<p>INTERSECTION LIGHTS SERVICE BULLETIN</p>	UP 124A REV 1 2016-02-25
		Page 1 of 1

AMBULANCE TYPE: MX151D

Units: 62911 to 62979

TITLE : INTERSECTION LIGHT « STEADY-BURN »
DEACTIVATION FEATURE
(UNIT 62911 TO 62979)

SERVICE PROCEDURE

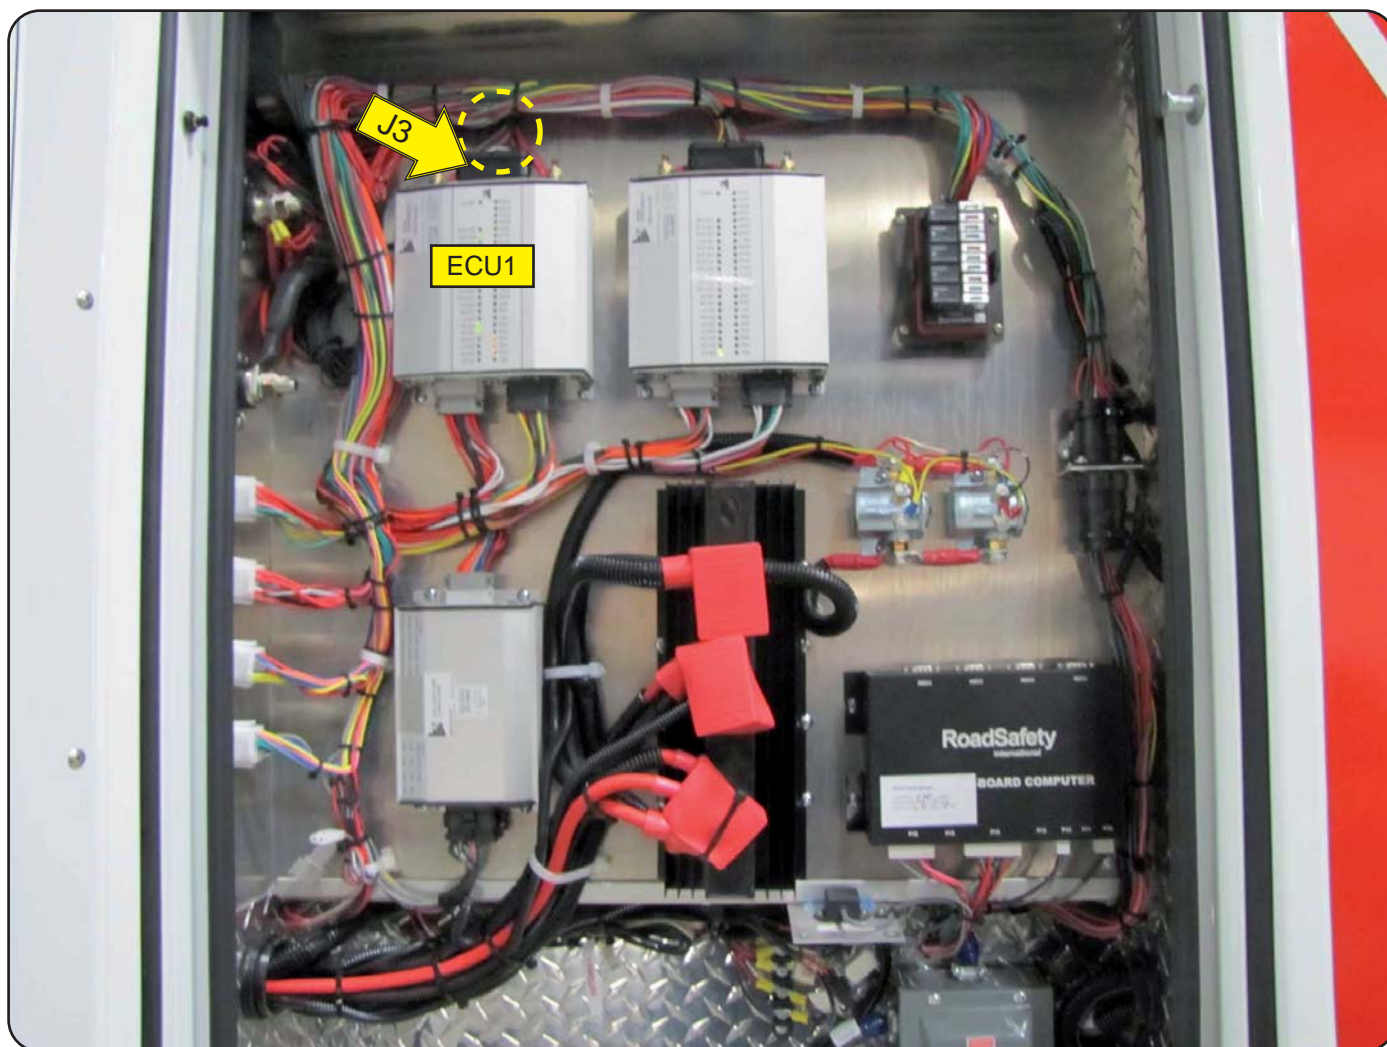
This bulletin is to inform owners of Demers Ambulances (unit numbers listed above) that a modification of wiring harness is required. Front fender intersection lights are activated with the left/right flasher and with emergency lights. Modification will consist of removing left/right flasher feature but emergency lights will continue to flash.

- 1 - Locate connector **J3** on **module ECU-1**.
- 2 - **Remove** connector **J3** and **locate pin 7 - left flasher / pin 8 - right flasher** (see diagrams on page 2)
- 3 - **Cut** and **insulate** wires at both ends on **pins 7 & 8** (yellow & green wires).
- 4 - Reinstall connector **J3** and **make sure left and right flashers work** on side and rear of the ambulance module.

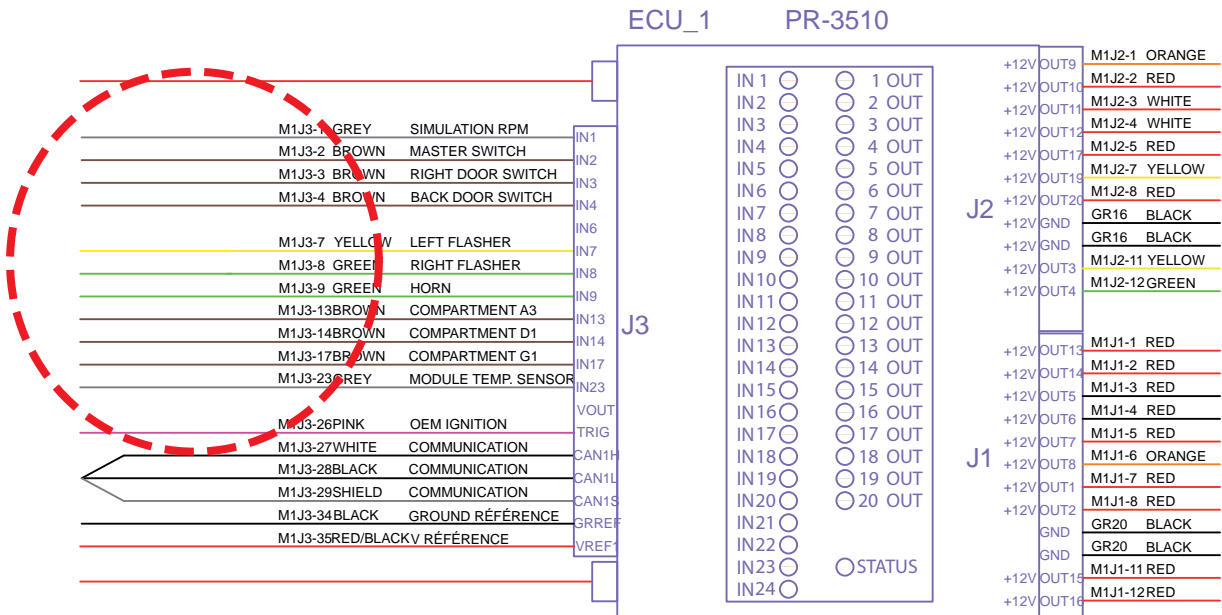
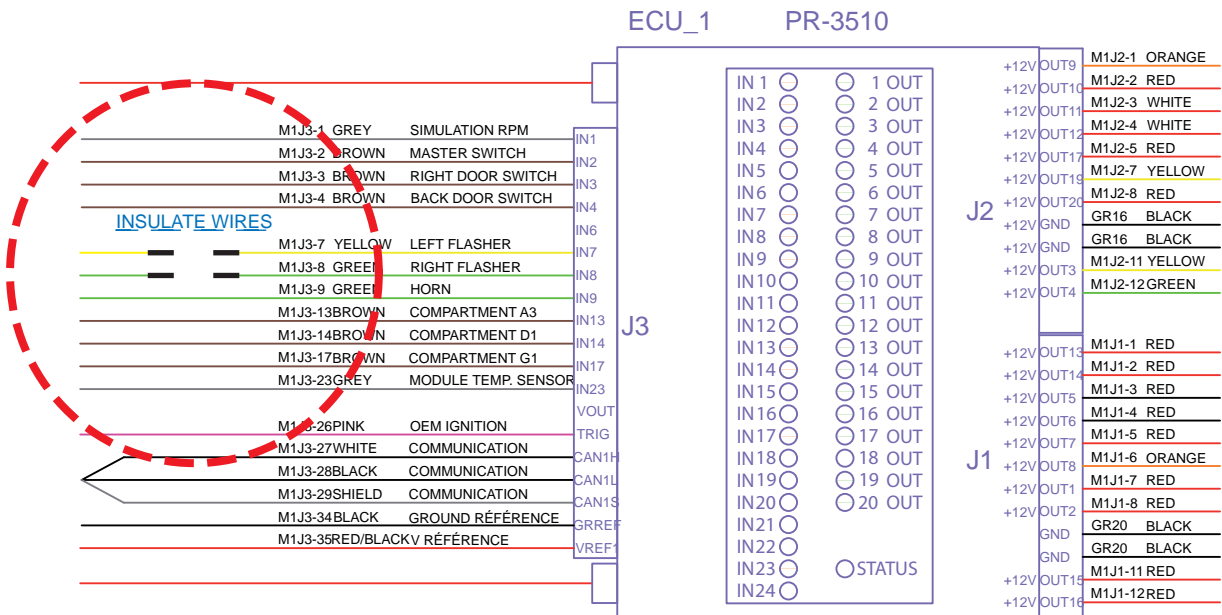
BEFORE MODIFICATION

AFTER MODIFICATION
